DRAFT Review Comments
Draft Storm Water Source Control Evaluation with Source Control Measures Performance
Monitoring Lampros Steel
Portland, Oregon
ESCI #2441
Report Dated August 28, 2023
Review Comments dated November 21, 2023

The following are the U.S. Environmental Protection Agency's (EPA's) **draft** comments on the document titled *Storm Water Source Control Evaluation with Source Control Measures Performance Monitoring* (SCE Report), dated August 28, 2023. This document was prepared by EVREN Northwest, Inc. for Johnson-Lampros Warehouse LLC. The Lampros Steel Facility (hereinafter referred to as the site) is located at 9040 N Burgard Way, Portland, Oregon, is listed as Environmental Cleanup Site Information (ECSI) #2441 and is upland of the River Mile 3.5 East (RM3.5E) project area of the Portland Harbor Superfund Site (PHSS). Stormwater from the site discharges to the International Slip through Outfall 18 (WR-123) approximately 600 feet to the west of the site.

Figure 1. River Mile 3.5 East Project Area and associated Outfalls

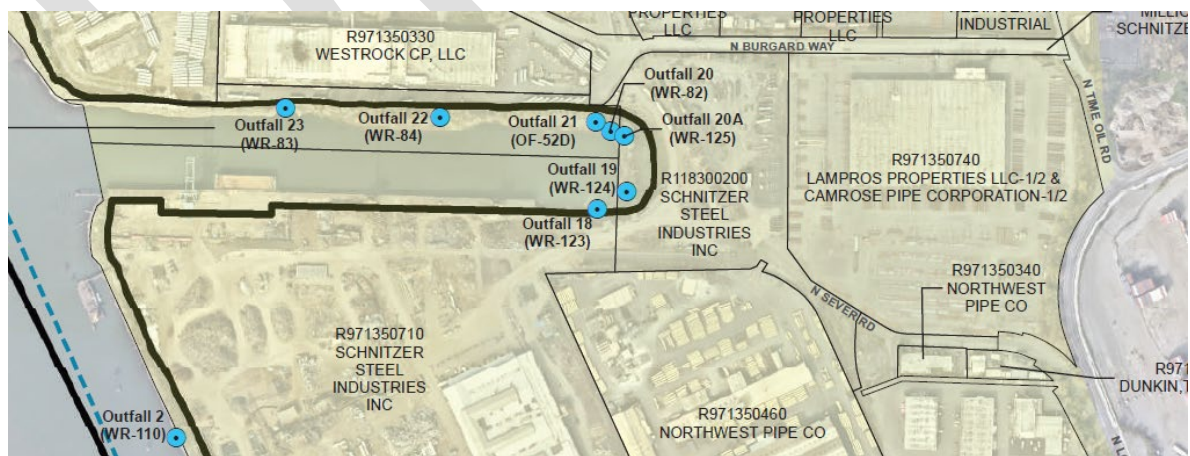
5. Verify the location of the outfall (APC216) shown in Figure 4 Storm Water Conveyance Map (Distal) is correct and update the figure and text, as needed. EPA believes Figure 4 is mislabeled and incorrectly shows the location of APC216, which is also known as Outfall 18/WR-123. EPA believes Figure 4 actually shows the location of Outfall 19/WR-124. Below is an excerpt of Figure 1.2 Project Area from River Mile 3.5 East Remedial Design Pre-Design Investigation Work Plan (Floyd Snider 2022) for comparison.
